MANCHESTER TOWNSHIP PLANNING COMMISSION AGENDA

- **RVW #2024-01 Eagle's View Phase 5 Final Subdivision Plan** – The applicant requests approval of a Final Subdivision Plan for 23 building lots in the Residential Low (RL) District. Tax Parcel #36-000-KI-0225.00-00000.

Re: Eagles View Park Phase 5 – **For 6/26/24 Planning Commission Meeting**
Final Subdivision Plan
Township Review No. 2024-01
Engineer's File No. 0841.3.05.36

We have reviewed the Final Subdivision Plan, submitted by James R. Holley & Associates, Inc., dated May 1, 2024. We offer the following comments:

FINAL SUBDIVISION PLAN FOR **EAGLES VIEW PHASE 5** SUBDIVISION PLAN
 WOODLAND VIEW ASSOCIATES, LLC
 MANCHESTER TOWNSHIP YORK CO., PA © 2024 James R. Holley & Associates, Inc.

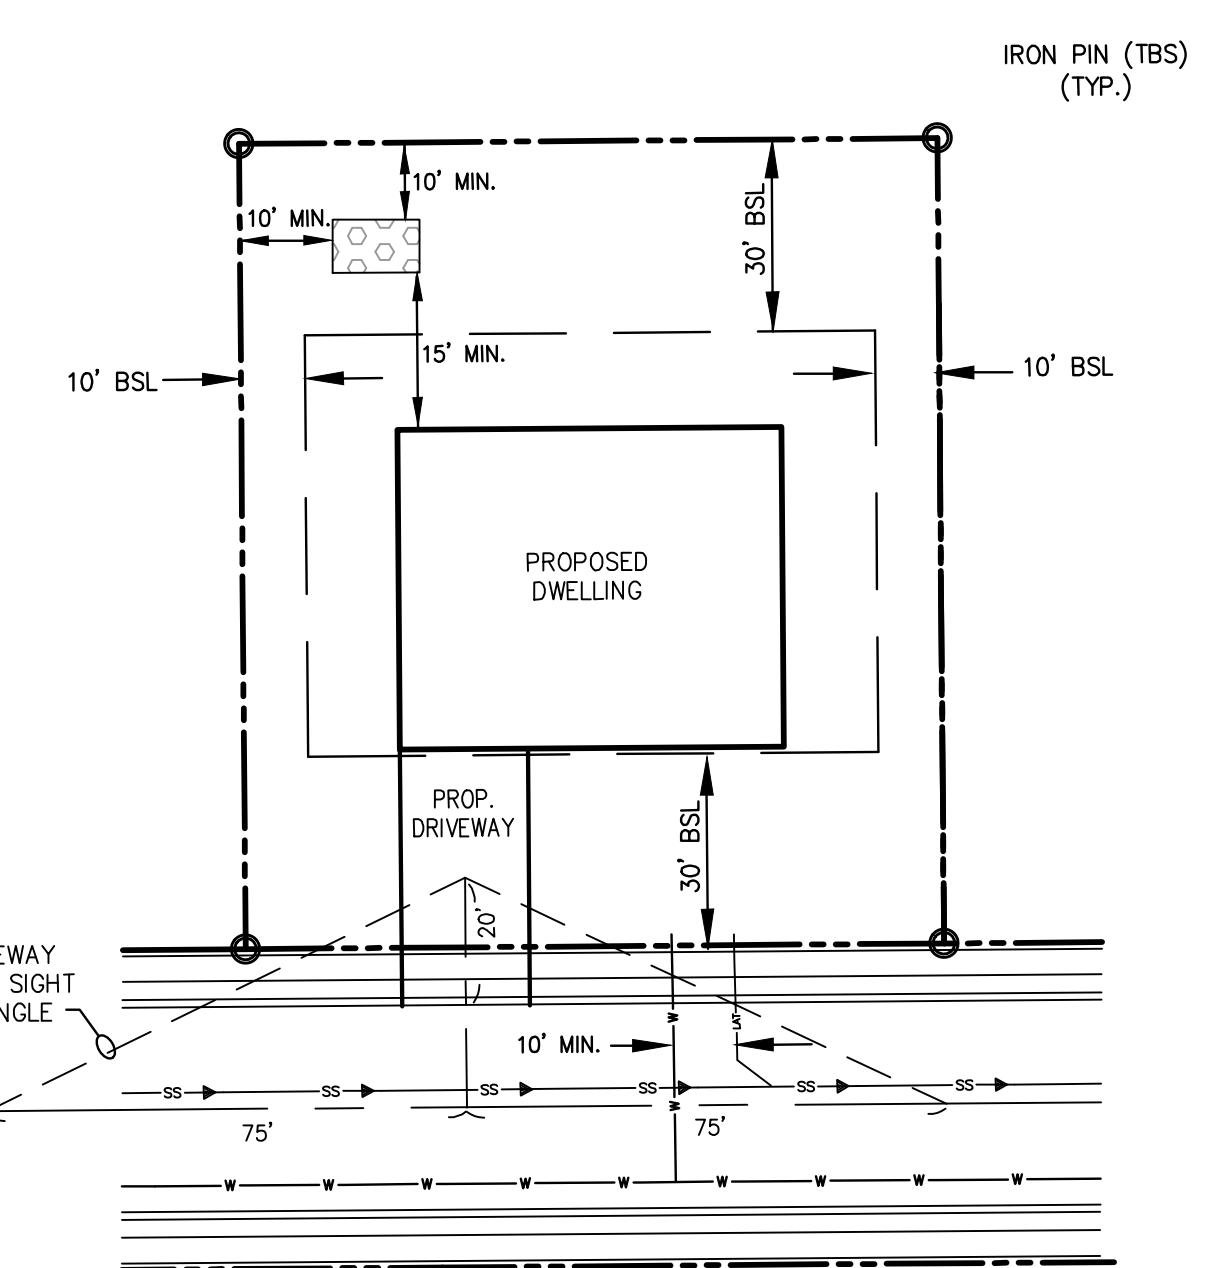
3. An easement or infiltration pit is hatched at the rear of lots 88-89 on sheet 6 and should be shown throughout the plan set. (§22-406.4.15)
4. It is unclear what is intended with Basin 'A' and should be clarified on the plans. (§22-406.4.16)

7. ~~It is unclear from the grading plan how runoff from the rear of lots 84-89 will be addressed.~~
8. Arrows shall be added to the plans to identify the street address of corner lots.
